TECHNICAL MEMORANDUM

RE: **SUMMARY OF JANUARY 6, 2016 TECHNICAL MEETING
JORGENSEN FORGE EARLY ACTION AREA
SEATTLE, WASHINGTON
U.S. EPA DOCKET NO. CERCLA-10-2013-0032
FARALLON PN: 831-032**

ATTACHMENT A
REQUESTED MODIFICATIONS TO THE OPERATIONS, MONITORING,
AND MAINTENANCE PLAN, ADDENDUM NO. 2

Requested Modifications to the Operations, Monitoring, and Maintenance Plan, Addendum No. 2

Attachments: Figure 1, *Interim Surface Sediment Sample Target and Actual Locations*
Attachment A, Requested Modifications to the Operations, Monitoring, and
Maintenance Plan, Addendum No. 2

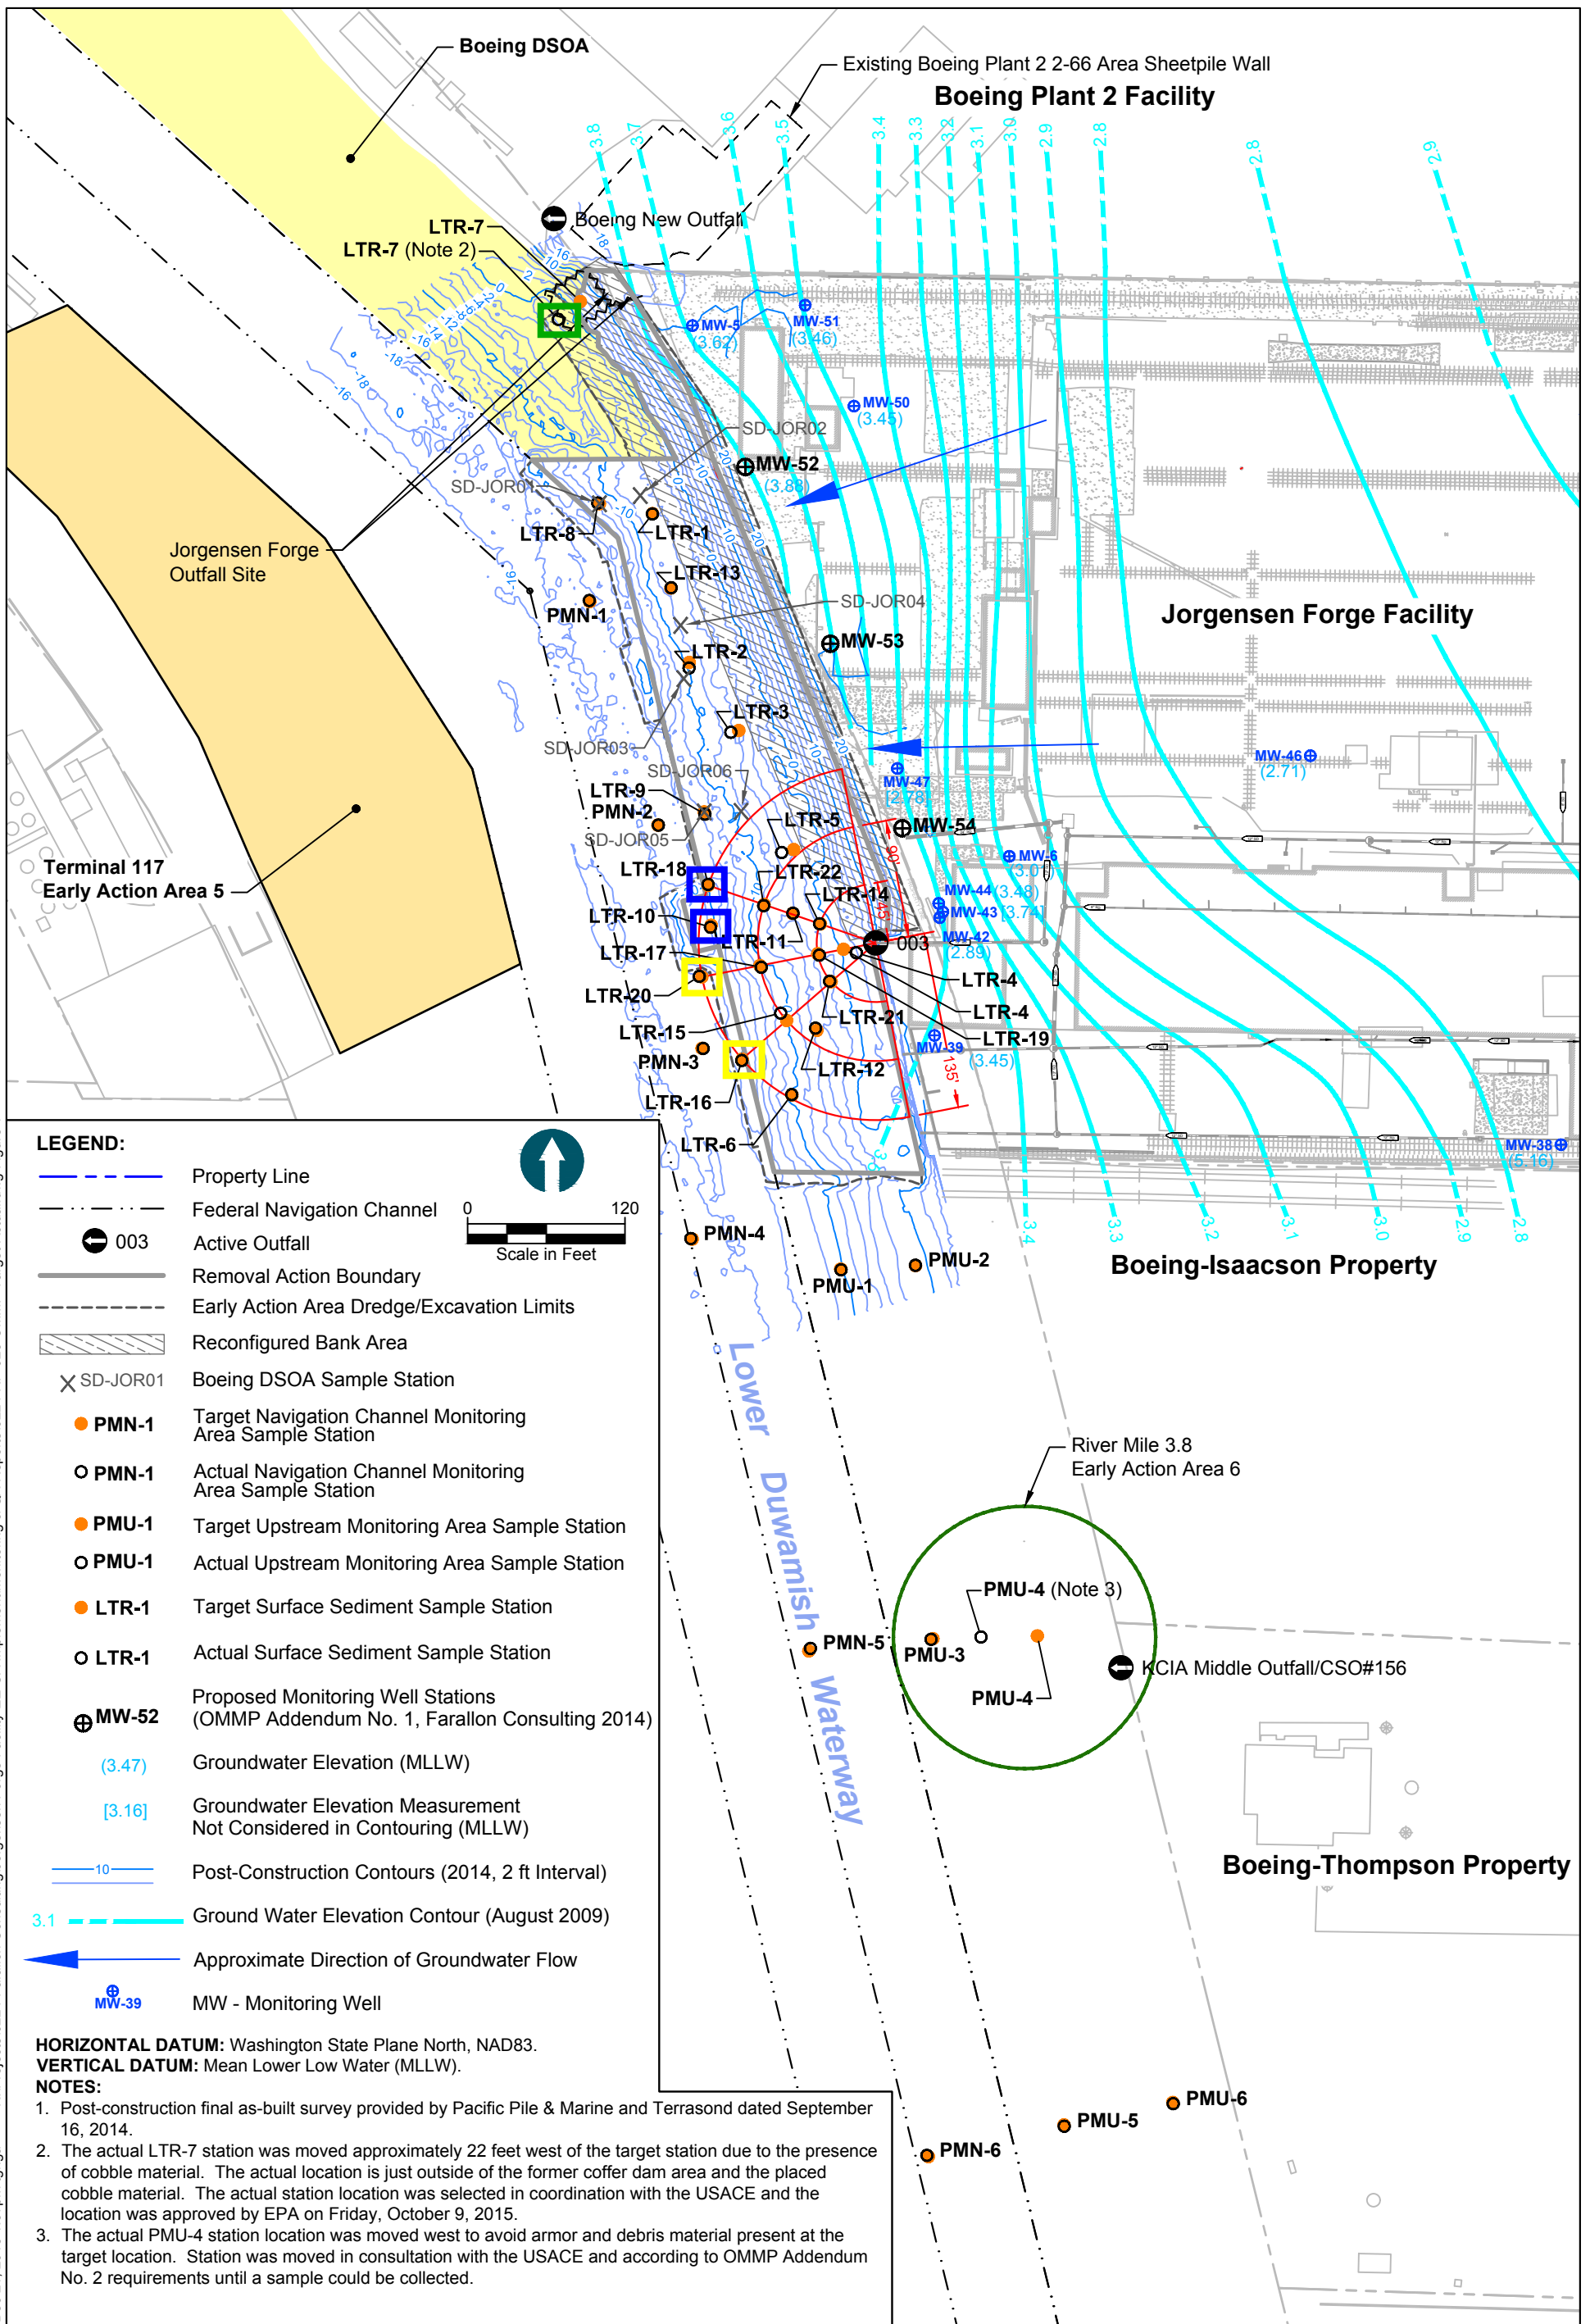
The following possible modifications to upcoming field work were discussed (Figure 1; Attachment A):

- Stations LTR-16 and LTR-20 are located outside the Remedial Action Boundary (RAB), where no backfill was placed. Whether the 0- to 60-centimeter (cm) sediment samples, originally intended to characterize backfill material, should be collected at these stations was discussed. It was agreed that the 0- to 60-cm sediment samples at these two stations will be collected and archived, in case the data become useful in characterizing impacts from stormwater discharged from Outfall 003.

- Stations LTR-10 and LTR-18 are located at the edge of the RAB, where a full 60 cm of backfill material may not be present. It was agreed that the core sediment samples will be inspected and photographed to identify the backfill material, and if the backfill material is less than 60 cm at these stations, the depth of these samples will be adjusted to collect the entire column of backfill material that is present without collecting underlying sediments. EPA and Farallon will be present during core sediment sample processing to verify the selected interval.

- The location of Station LTR-7 was adjusted during the October 2015 sampling event due to difficulty collecting the surface sediment intervals with the Van Veen sampler because of the hard substrate present there. It was agreed that the 0- to 2-cm and 0- to 10-cm surface sediment intervals for this station will be collected at the revised location of Station LTR-7 during the January 2016 sampling event for consistency and to avoid similar sampling difficulties.

- Resolution was not fully reached on core sediment sampling at Station LTR-7. Farallon agreed to attempt core sampling at the original Station LTR-7 location, and will defer to the operator's judgment regarding potential damage to the coring/drilling equipment that may be caused by attempting to drill through the riprap and cobble that is present. Should core sediment samples be unobtainable at that location or elsewhere within the former coffer dam area, a final decision was not reached on whether 1) core samples should be taken at the revised Station LTR-7 location, which is just outside the former coffer dam area; 2) another approach to collecting the Station LTR-7 core samples should be attempted (e.g., angled drilling); or 3) to rely on the z-layer sample already collected if a core sample cannot be collected under existing conditions. EPA and Farallon agreed to consider this issue and consult with the USACE and Anchor QEA, LLC (Anchor QEA) regarding possible alternatives.

1. Section 2.2.1, Stations LTR-16 and LRT-20 (yellow squares, Figure 1). These two stations are the outermost stations required by the U.S. Environmental Protection Agency (EPA) to characterize potential impacts from Outfall 003. At the planned distance, they fall outside the Remedial Action Boundary (RAB), where no backfill material was placed. Therefore, the 0- to 60-centimeter (cm) sampling interval will not meet its objective to characterize the backfill material.

2. Section 2.2.1, Stations LTR-10 and LTR-18 (blue squares, Figure 1). These two stations are at the edge of the navigation channel and may have less than 60 cm of backfill material above native material. The 0- to 60-cm interval is intended to characterize the quality of the backfill material and ideally should not include underlying sediments.

3. Section 2.2.1, Station LTR-7 (green square, Figure 1). As described in OMMP Addendum No. 2, Section 2.2.2.1, and confirmed during the October 2015 sampling event, collection of samples at the original location may not be possible due to the presence of 6 inches of cobble material overlying 1.5 feet of riprap within the former coffer dam area. During the October 2015 surface sampling event, in coordination with EPA, the station was relocated as close as possible to the originally planned location. The relocated station was outside the RAB and within the Boeing DSOA, where no backfill material was placed by EMJ.

Alternatives for core sampling include: 1) collecting core samples at the revised LTR-7 location, although this station does not meet the objectives of core sampling; 2) identifying an alternative approach for collecting a core sample within the former coffer dam area; and 3) relying on the existing z-layer sample collected in this area. EPA/COE and EMJ are continuing to consider these alternatives.

Proposal: Collect the 0- to 2-cm and 0- to 10-cm intervals as planned at these stations. Collect and archive the 0- to 60-cm interval at these stations.

Proposal: Should inspection of the core identify less than 60 cm of backfill material present in the core, EPA will be notified and requested to approve collection of a core interval that includes the entire depth of backfill material at each station. Photographs will be taken to document the need for the deviation and written documentation will follow the field decision. EMJ will plan ahead and inform EPA of when these samples will be processed to ensure that all parties are available to observe and approve the modification within the time constraints of sample processing for laboratory analysis.

Partial Proposal: Collect surface sampling intervals (0- to 2-cm and 0- to 10-cm depths) at the revised LTR-7 location, consistent with the October 2015 sampling location. A decision on the core sampling is pending as noted above.
